AMENDMENTS TO THE DRAWINGS:

REMARKS

The present invention relates to a vehicle hydraulic brake device, and four preferred embodiments thereof are disclosed in connection with Figs. 1-4, respectively. For example, in Fig. 1, a "hydraulic passage" 12 leads from a pressure adjusting valve 3 to wheel cylinders 7-1 and 7-2 (and a hydraulic passage 12, 16 leads from the pressure adjusting valve 3 to wheel cylinders 7-3 and 7-4). A hydraulic pressure supply passage 20 supplies hydraulic pressure from the hydraulic pressure source to the hydraulic passage at a junction J therewith (see the drawing amendment for the reference letter J). A first proportional solenoid valve 21 is provided in the hydraulic pressure supply passage 20 for reducing the output hydraulic pressure of the hydraulic pressure source to a first value before it is supplied to the hydraulic passage 12. A second proportional solenoid valve 22 is provided in the hydraulic passage 12 at a location between the pressure adjusting valve 3 and the junction J. The second proportional valve 22 is operable for reducing the output hydraulic pressure supplied from the hydraulic pressure supply passage. A check valve 23 is provided

Fig. 1

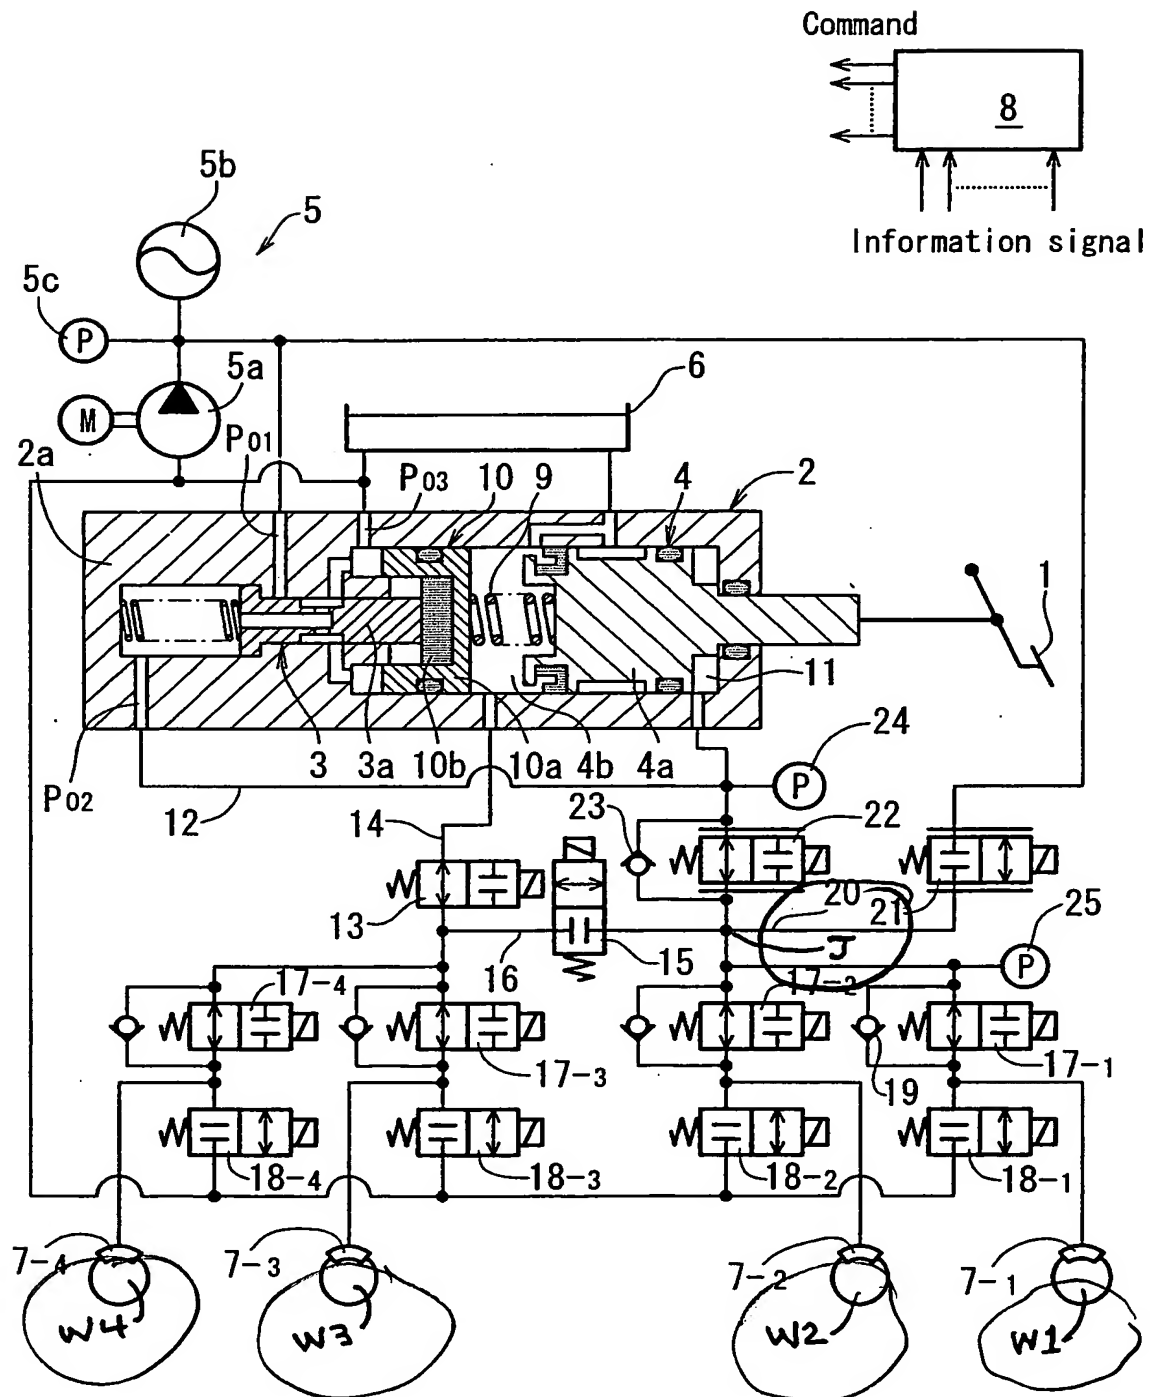
Each of Figs. 1-4 have been amended by inserting "J" and "W-1, W2, W-3, and W-4" therein.

Fig. 3

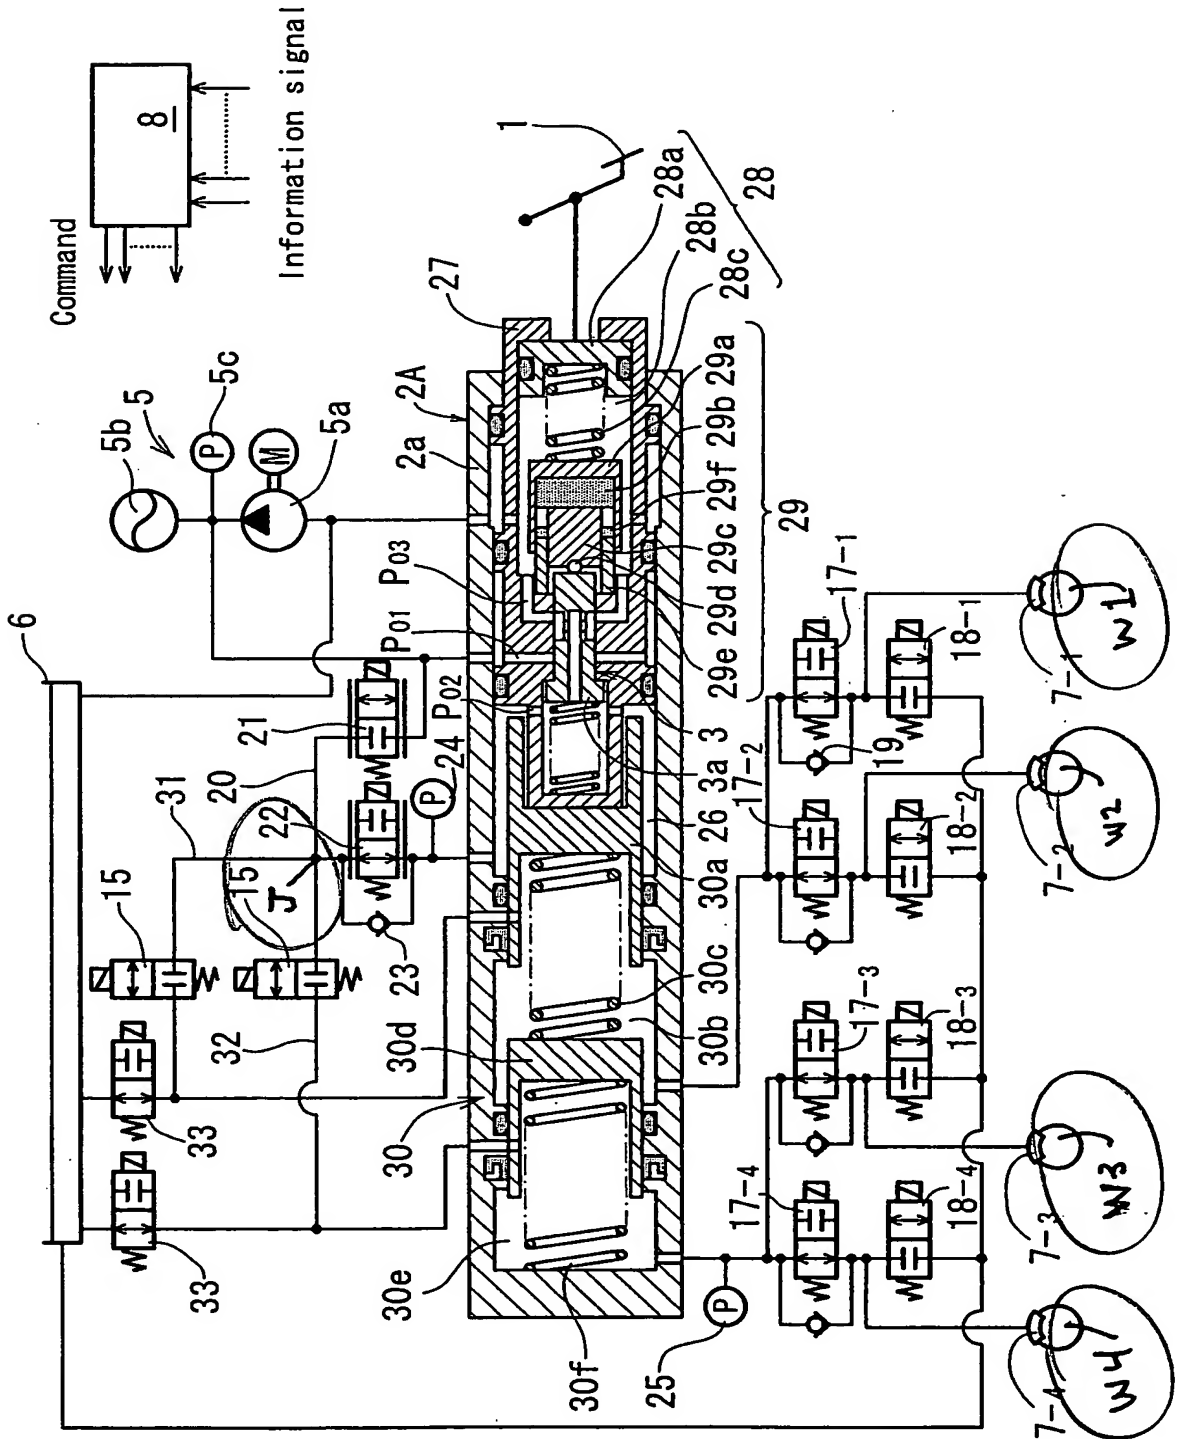
Independent claims 2 and 3, which are readable on the embodiments of Figs. 3 and 4, respectively, also distinguish patentably over Ota et al for the same reasons as applied to claim 1.
